41 Chatsworth Drive – Official Plan and Zoning By-law Amendment Applications – Request for Direction Report

Date: November 16, 2020

Planning Application Number: 17 277580 NNY 16 OZ

Site Plan

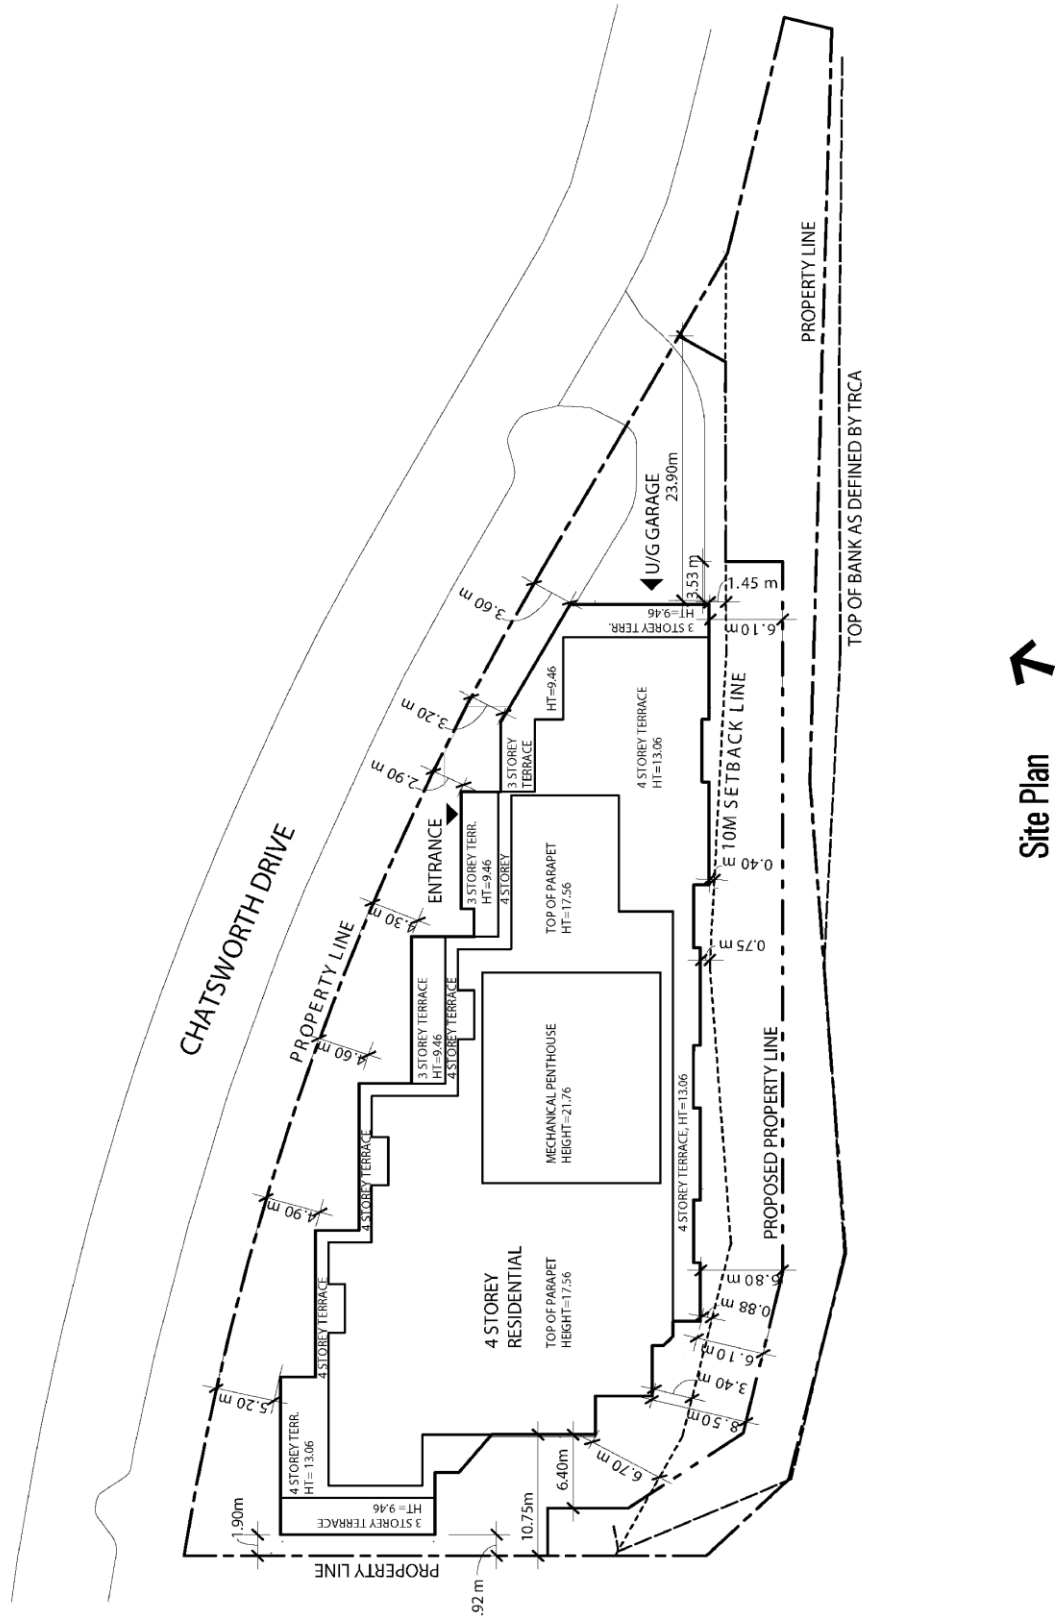
The proposed building's transition to its neighbours, in particular the detached dwelling immediately to the west, at 57 Chatsworth Drive, results in a poor relationship based upon a narrow setback. The applicant has proposed a building setback of 1.9 metres from the west lot line for approximately the same or a similar depth as the neighbouring dwelling. The submitted survey plan illustrates that the dwelling at 57 Chatsworth Drive is located between 0.10 and 0.23 metre from the existing lot line. The height of the proposed building is 2 storeys above grade in this location and a window is proposed on each of the two floors mid-wall. City Planning staff would like to see this setback increased to provide more breathing room between the existing dwelling and the proposed development.

also not indicated on the site plan where short term visitor bicycle parking would occur on the site. This information needs to be provided.

Drawing A1-01 (dated by the Architect October 14, 2020) demonstrates that the applicant is proposing a 19.53 square metre on-site parkland dedication, with at least a 24 metre setback between the park boundary and the east building face.

Parks, Forestry & Recreation have advised City Planning that the 19.53 square metre parkland dedication proposed by the applicant is not an appropriate size. Given the constraints of the development site, should an appropriate balance of an on-site parkland dedication and residual cash in lieu not be possible, a request will be made for the entire parkland dedication requirement to be fulfilled through the provision of cash-in-lieu. Staff will continue to work with the applicant and prioritize maximizing the on-site dedication.

- Reduce the building massing to minimize the shadows on Chatsworth Drive during the spring and fall equinoxes;
- Increase the building setback from the north, west and south lot lines to minimize the impact upon the neighbour to the west and provide an appropriate building setback along the public street, and sufficient room for maintenance of the building abutting the ravine;
- Demonstrate that there will be sufficient amenity areas on-site for children and pets in keeping with the Growing Up Guidelines and the Pet-Friendly Guidelines;
- Reduce the amount of resident parking in keeping with the Zoning By-law and recognizing the proximity to the Lawrence subway station;
- Retain healthy city-owned street trees to the extent possible; and
- Provide on-site parkland satisfactory to the city.

Attachment 6: North Elevation (from Chatsworth Drive)

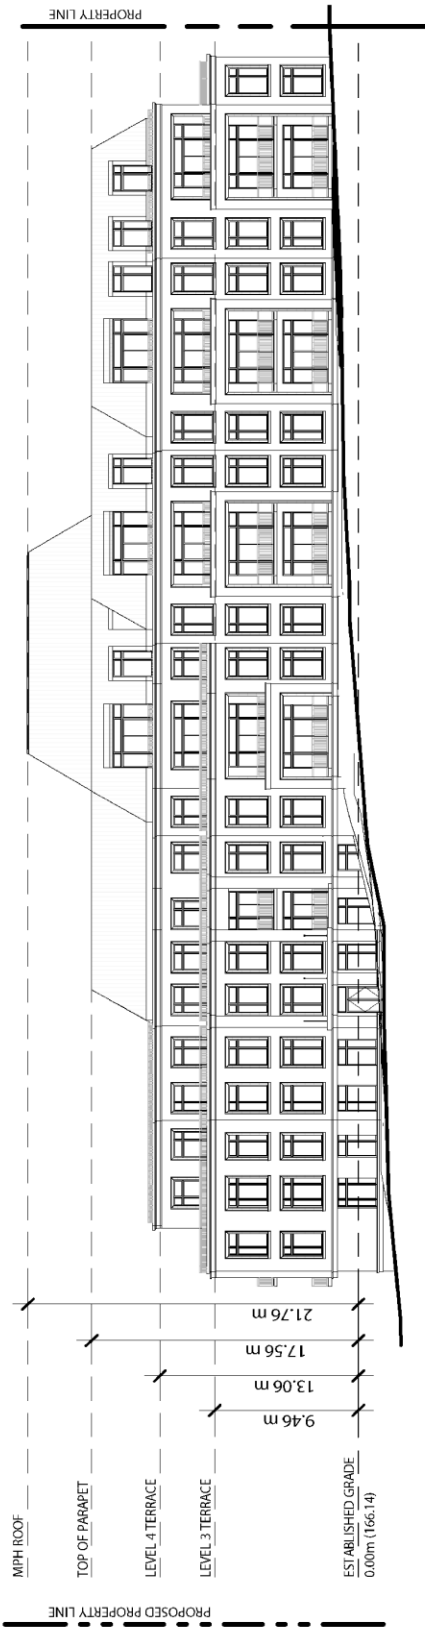
While the proposed building is of a height that is less than the abutting right of way for Chatsworth Drive, the building is tall for a 4-storey building. The floor to ceiling heights in excess of 3 metres high are greater than a typical detached dwelling. City planning staff recognize that this is a reflection of the market that the applicant is catering to. However, that does not provide a reason for the applicant to ignore a design which sensitively addresses other nearby properties. Moreover, as will be discussed below, the height of the building is casting shadows onto the Chatsworth Drive sidewalk for more hours during the day than is appropriate. Lowering the height of the building is one way to resolve this matter.

The proposed building face along Chatsworth Drive is long at more than 85 metres. The site topography is such that the building is proposed to be built into the hill as one travels west on Chatsworth Drive. The proposed building massing, including inadequate stepbacks, combined with the tall floor to ceiling heights result in shadow impacts on the Chatsworth Drive nearside sidewalk in front of the development during the spring equinox, as discussed in more detail below in the section on shadows. The shadows on the sidewalk, occurring for more than five consecutive hours during the spring and fall equinoxes, would be remedied by increasing the building setback from Chatsworth Drive or providing additional or greater stepbacks at upper levels of the building.

The 2017 shadow study illustrates that segments of the Chatsworth Drive sidewalk and public realm abutting the development site will be in shadow during the day, beginning at 9:18am through to 6:18pm. An updated shadow study which reflects the current proposal may illustrate better results but on the basis of the information that City Planning staff have, the proposed development is not supportable in terms of built form.

Planning staff are of the opinion that revisions should be made to the proposal's built form, setbacks, stepbacks and massing to reduce its shadowing impacts, on the Chatsworth Drive sidewalk and public realm during the spring and fall equinoxes. Additionally, City Planning requests the applicant to submit an up-to-date shadow study to reflect changes to the proposal.
